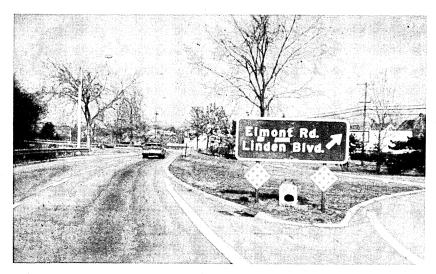
Mr. May. They will never get to it, because they will smash into that concerete pedestal?

Mr. Linko. This is right. I would like to point out this is Interstate. I think we should get some maintenance.

Mr. Cramer. There is another example of those light posts going up the ramp, constituting a hazard, when they could just as easily be put on the wall. Is there any reason why those lampposts could not be put on the wall? on the wall?

Mr. Linko. Here also you see a new sign just installed and there is a concrete stanchion there between the legs. Nobody thinks of removing it. This is an easy-knock-down sign. It (the stanchion) is not serving any purpose at all.

Here also you see a sign knocked down two 2 years ago and the stanchions are still there. A small sign has since been put in.

Mr. Prisk. No, sir.
